24 August 2016

**PROJECT: RESOURCECO WETHERILL PARK DEVELOPMENT 35 – 37 FRANK STREET, WETHERILL PARK  
NSW  
RE: MINOR AMENDMENTS TO STATE SIGNIFICANT DEVELOPMENT APPLICATION SSD 15\_7256**

**Re: Resource Co Resource Recovery Facility,  
35-37 Frank Street, Wetherill Park - Landscape Statement**

SITE PLAN

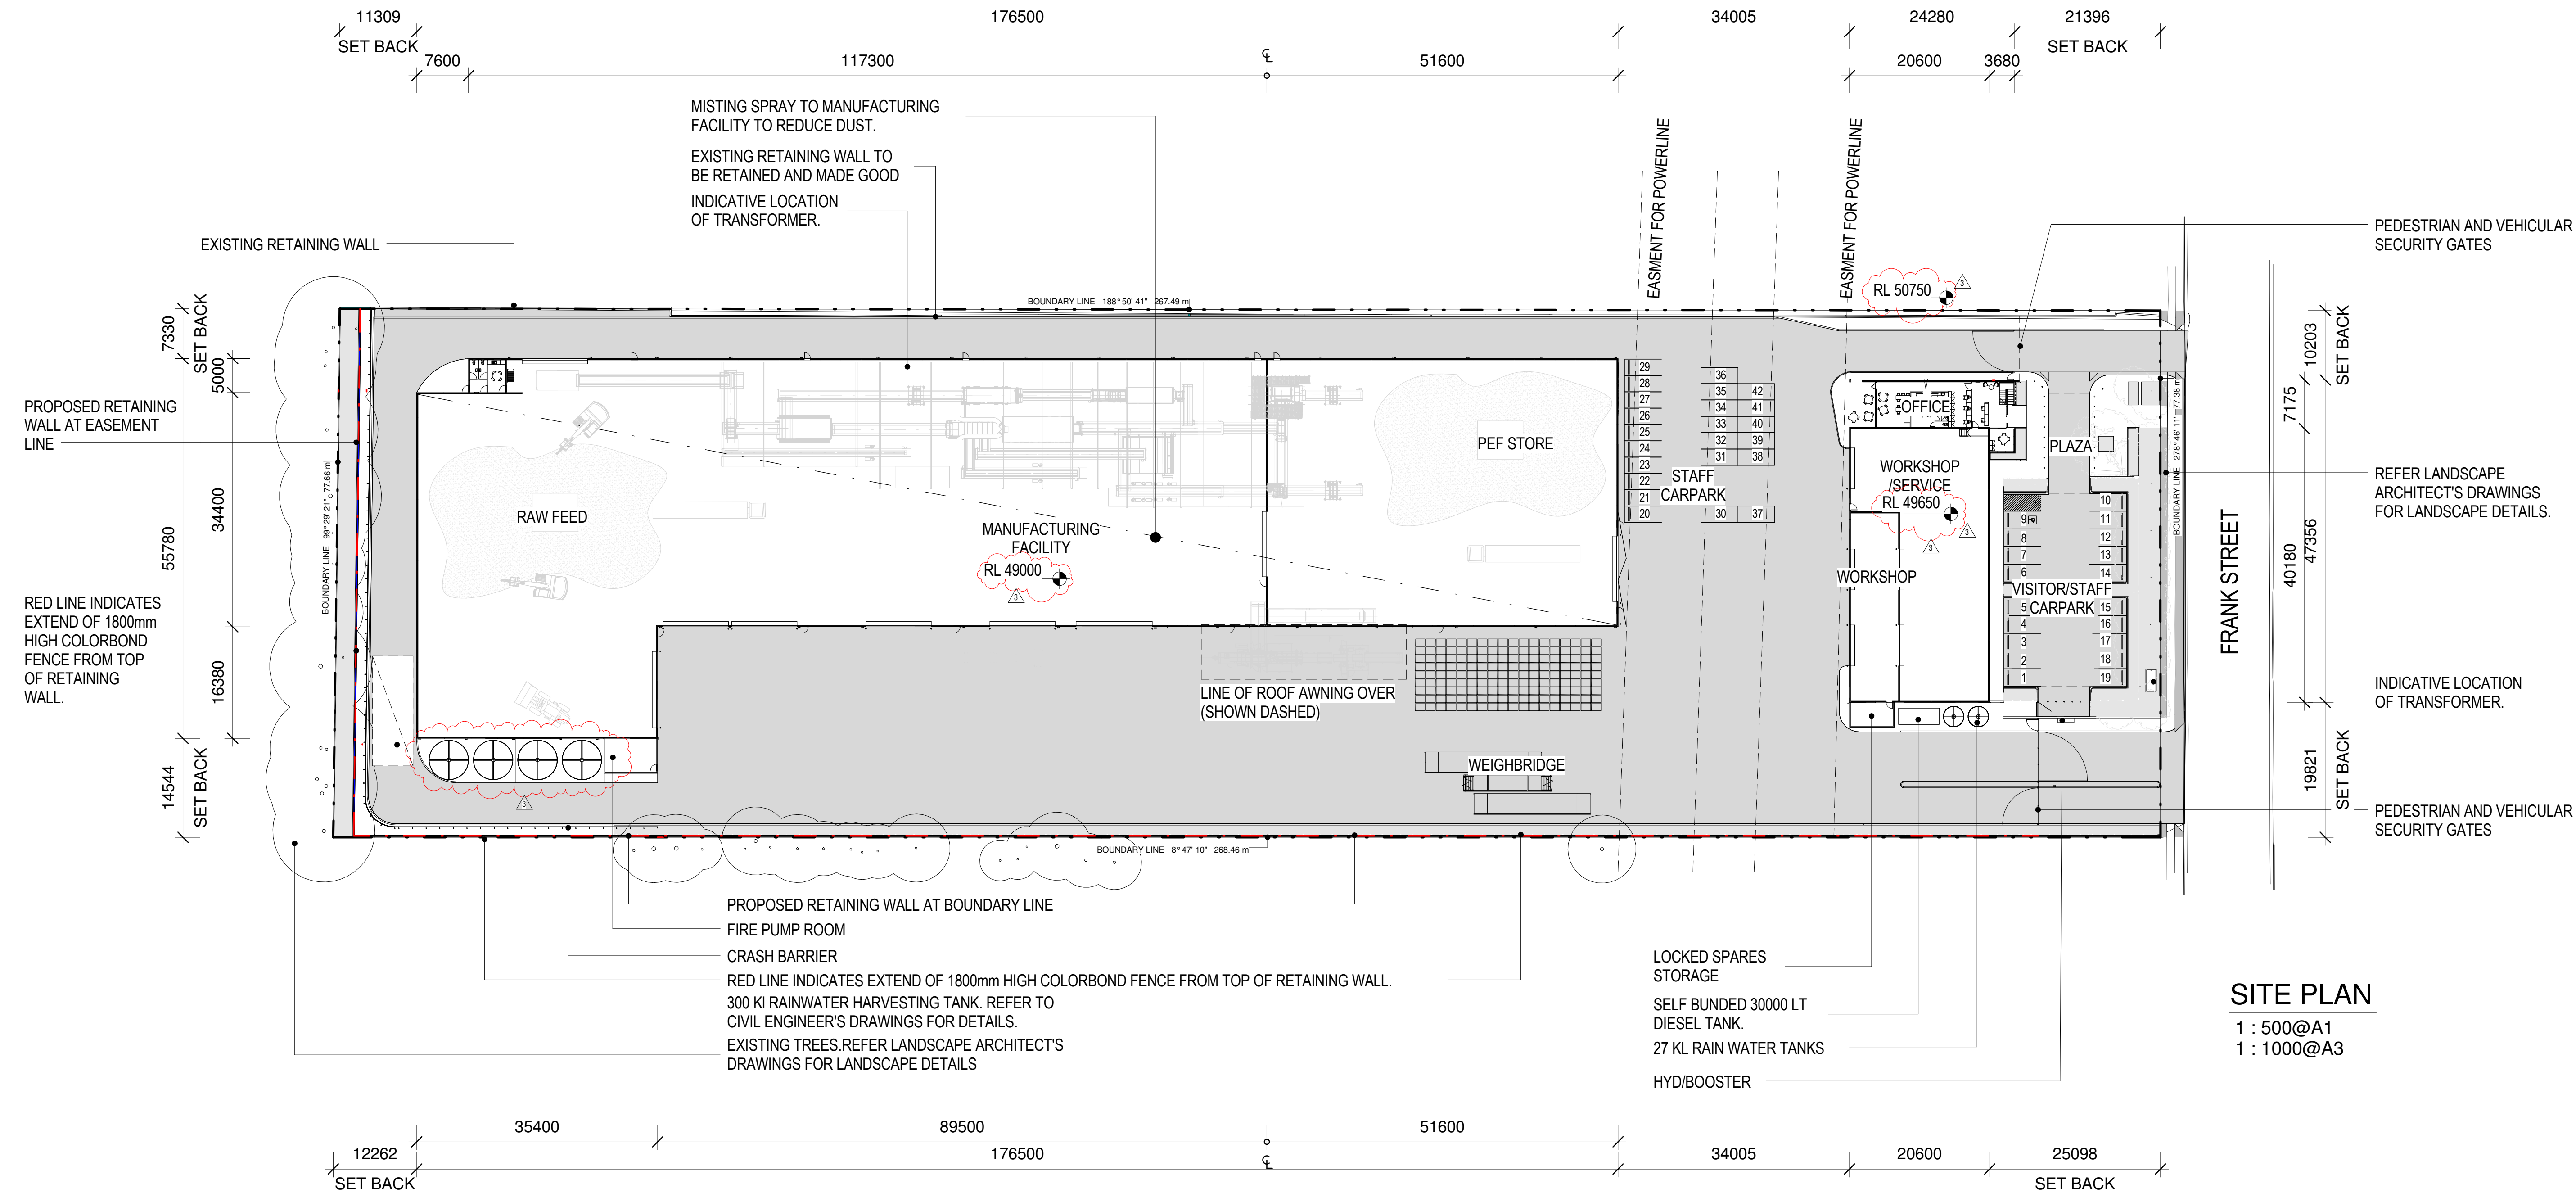
- The internal finished floor level of the Manufacturing Hall has been lowered by 500mm to RL 49.00.
- The Workshop area has been lowered by 450mm to RL 49.65.
- The Administration area has been lowered by 300mm to RL 50.75.
- The levels of the front of the site have also been adjusted so that the carpark is more closely aligned with the natural site levels which reduces the number of retaining walls required and site fill in this location. This has removed the need for the stair to be able to access the carpark on the western side of the site near the truck entry.

These amendments have required some adjustment to pavement levels and associated retaining walls. In principal these changes have moved to reduce the requirements for significant retaining walls along the western and northern boundaries of the site, as well as reducing the mass and impact of the buildings and retaining walls at street level.

## WESTERN BOUNDARY STUDY

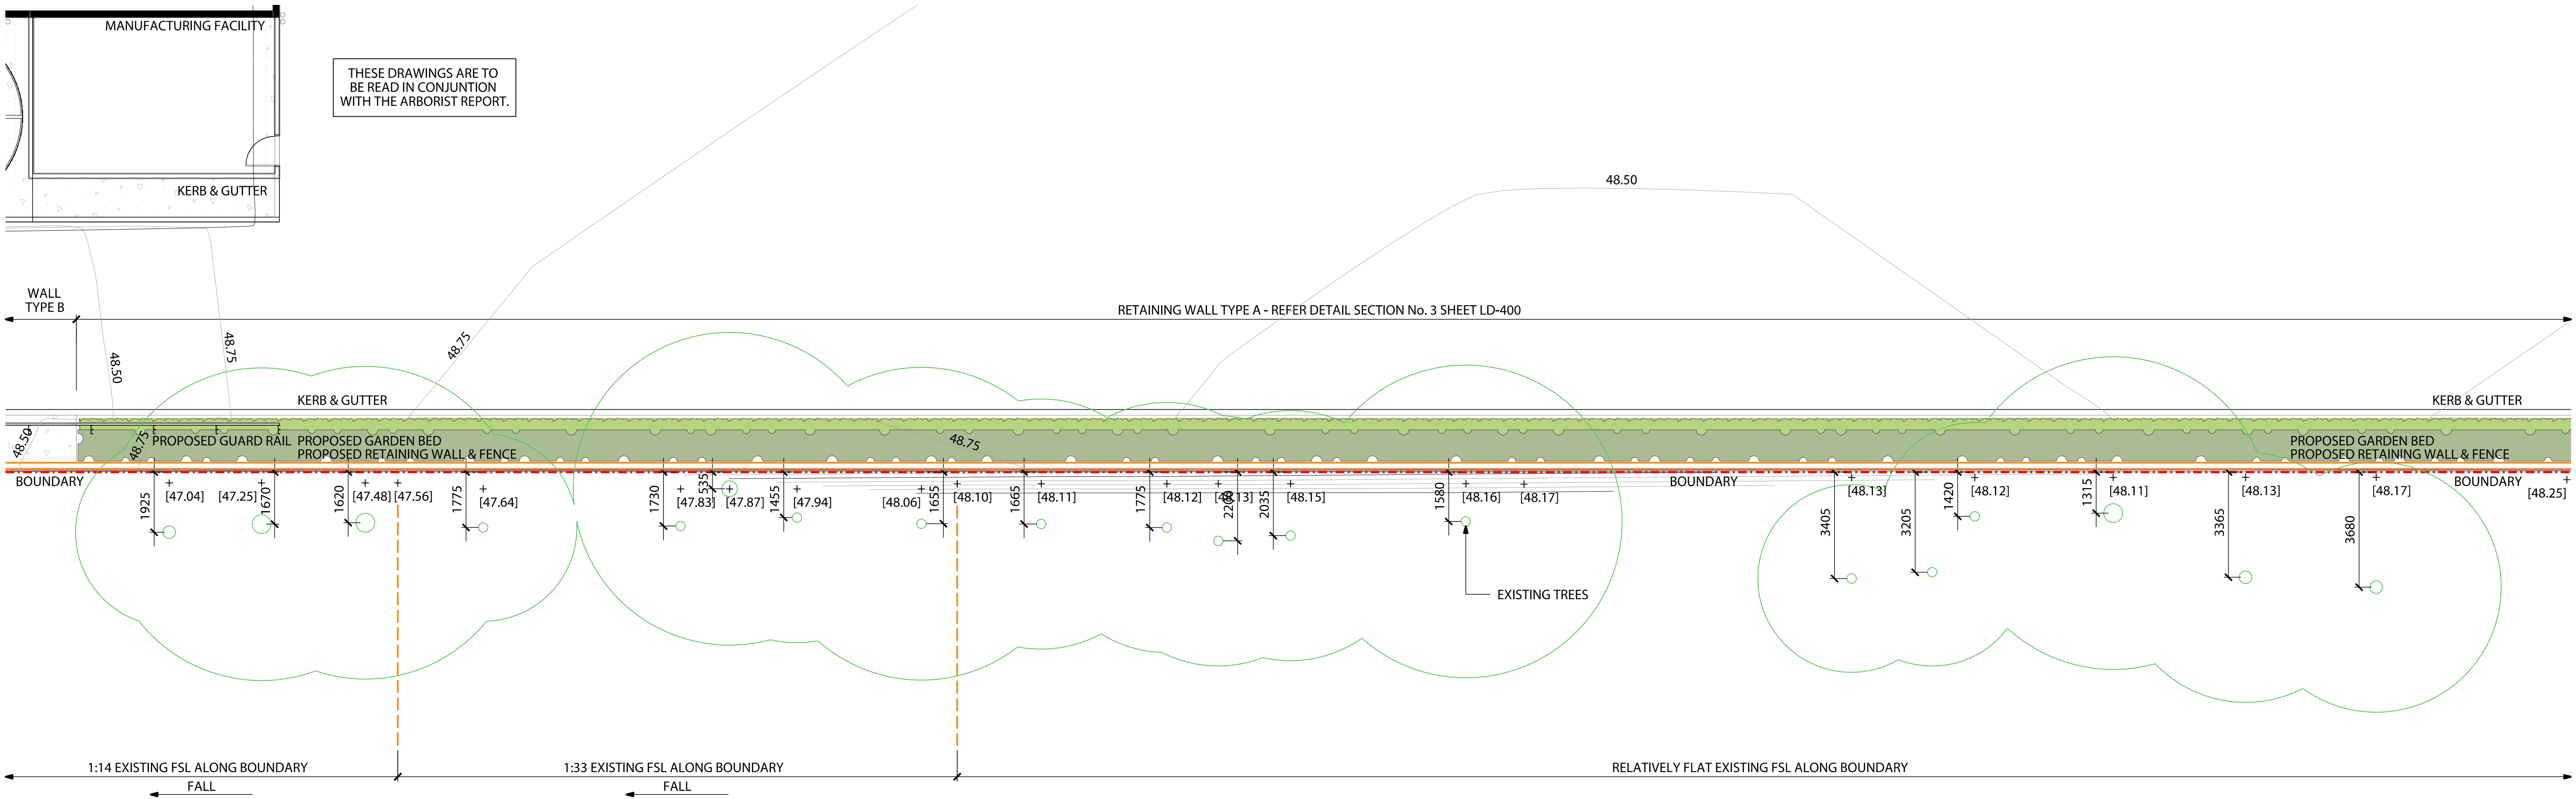
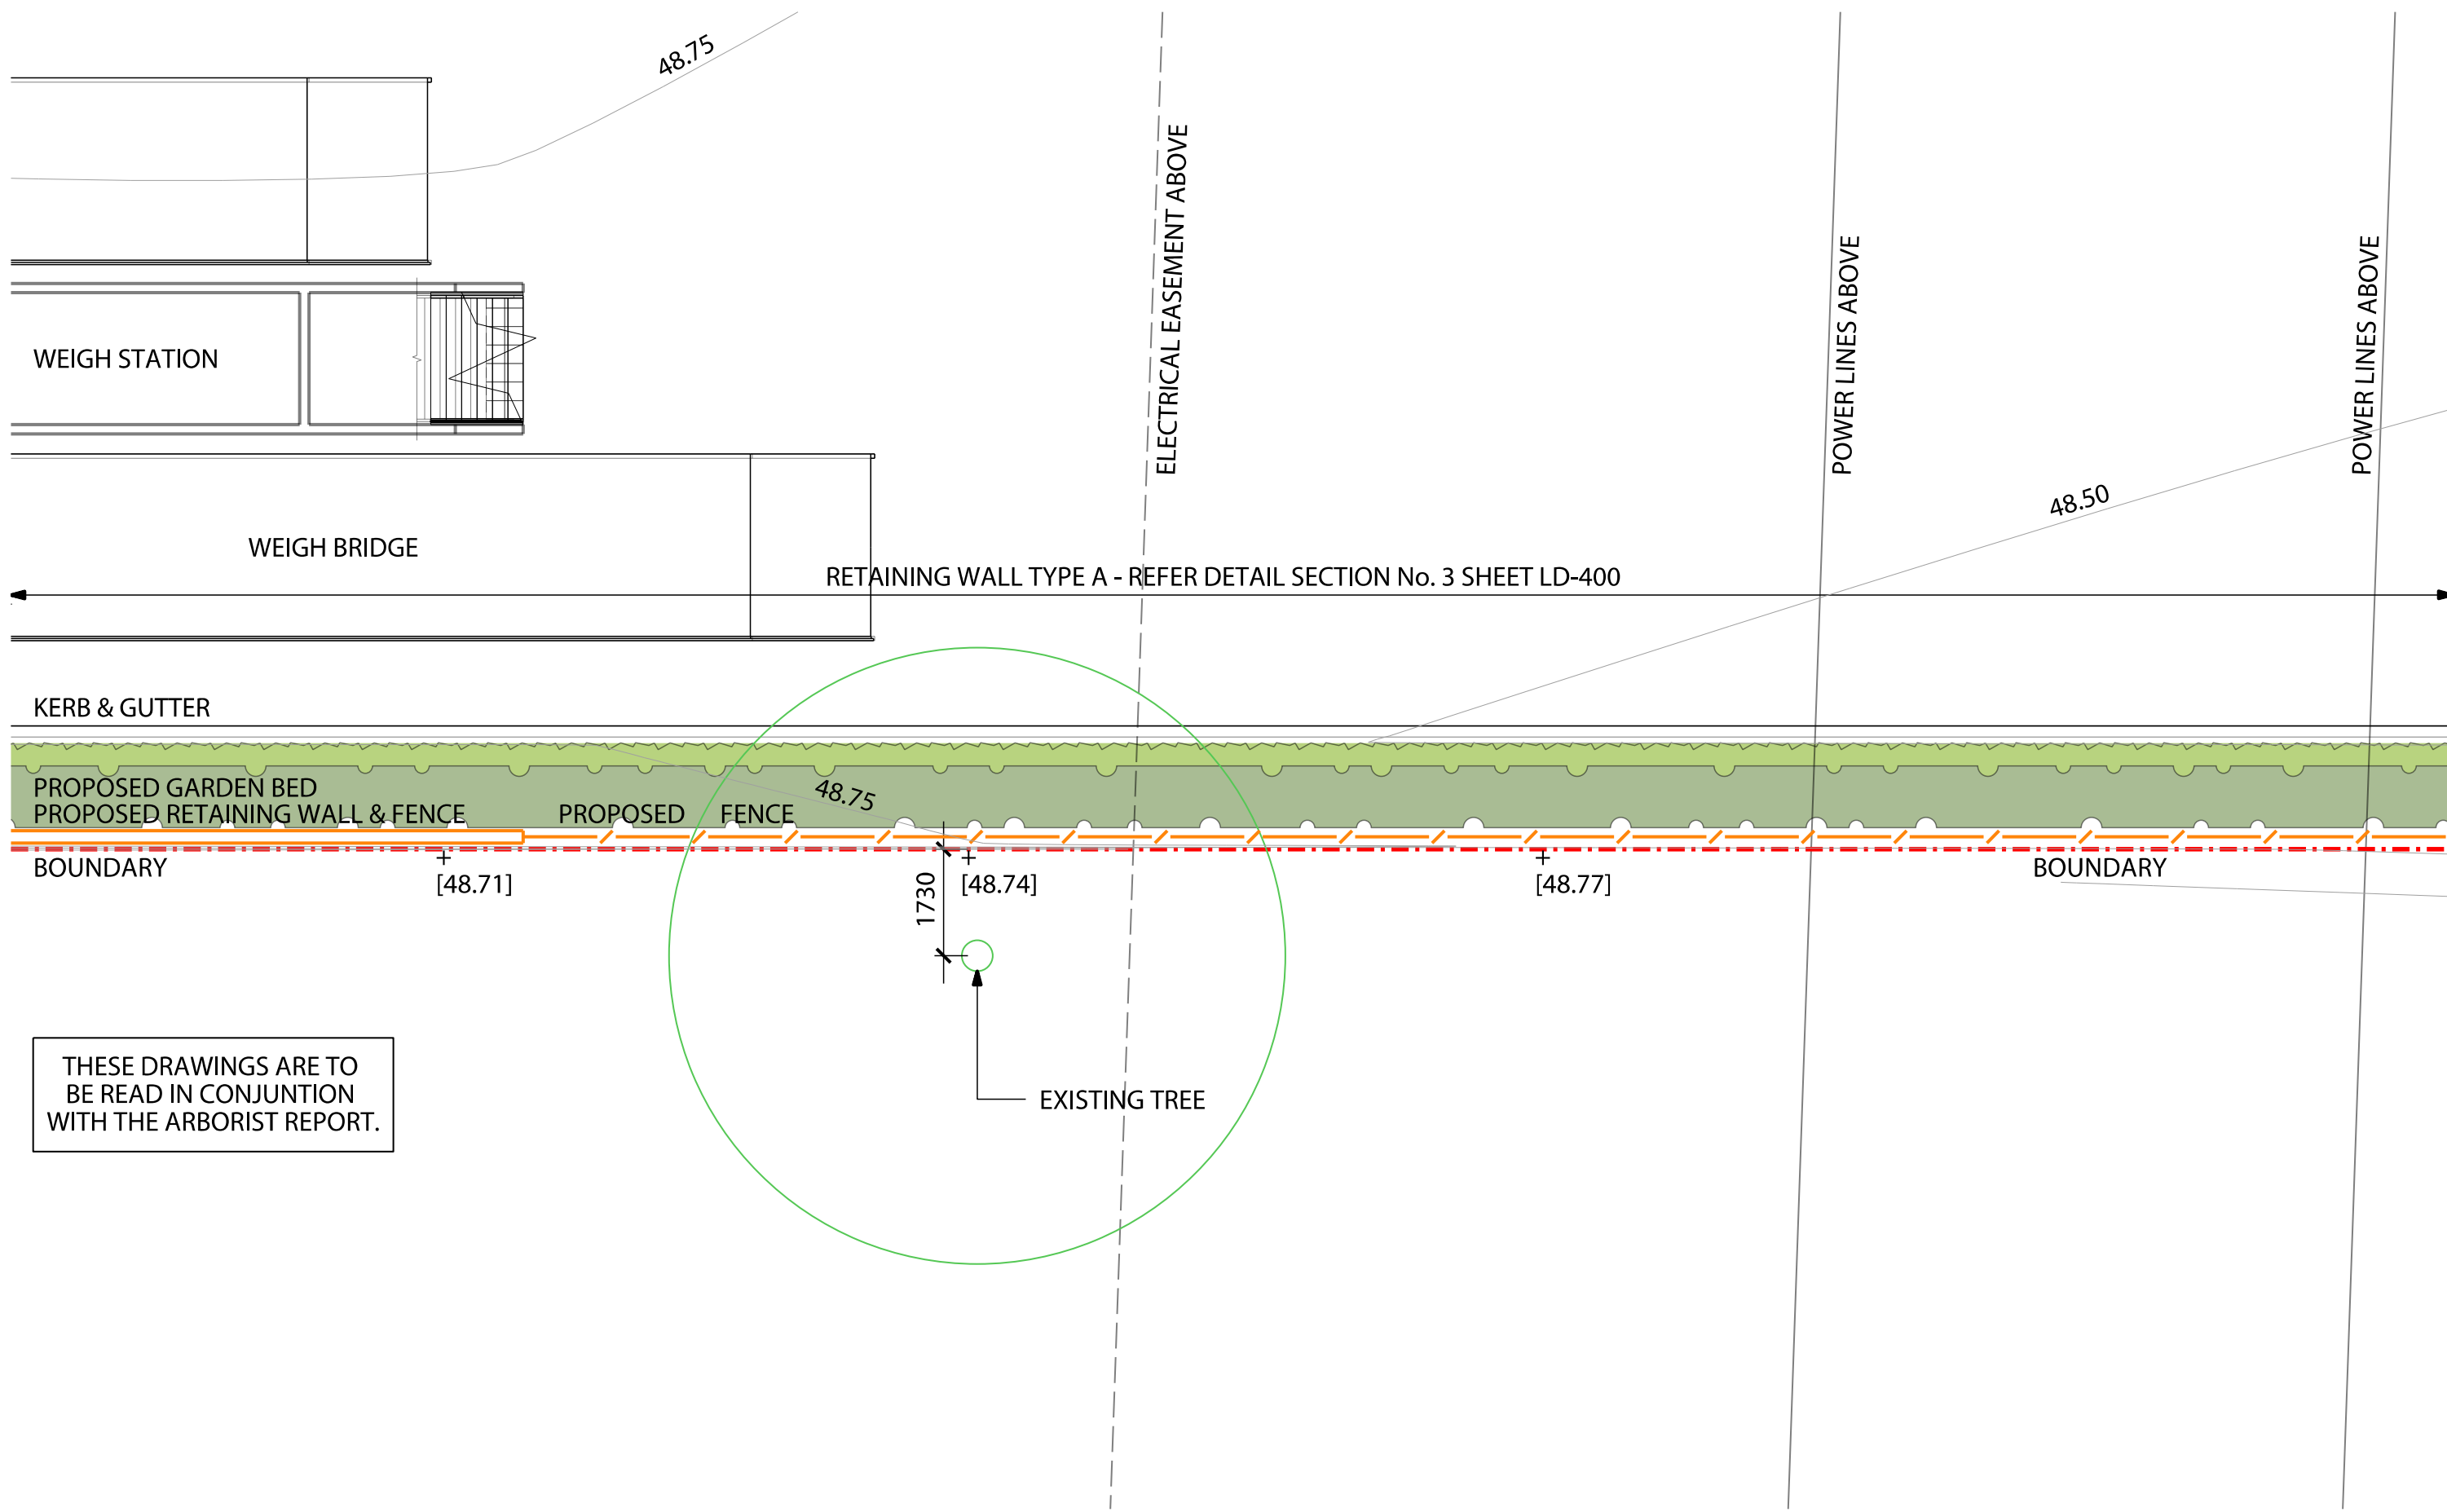
As a result of the revised site levels, the retaining wall to the Northern boundary has been reduced from 5.2m high to 3.25m high. The retaining wall to the Western boundary has been reduced in height and length (terminating near the weighbridge). There is a stronger street address (i.e. better visual connection / less segregation) with Frank Street as the reduced site levels have negated the need for retaining walls along the Southern boundary and allowed for a slight increase in garden bed area.

Along the Western boundary a variable height retaining wall is still required to accommodate a variable level shift of the neighbouring industrial estate. This retaining wall system has been designed to minimise impact on the root zone of the existing neighbouring trees, in accordance with arborist recommendations. A 1.8m high fence will be installed along the retaining wall and return along the northern boundary. The western boundary will also be planted with screening shrubs and grasses to improve visual amenity.
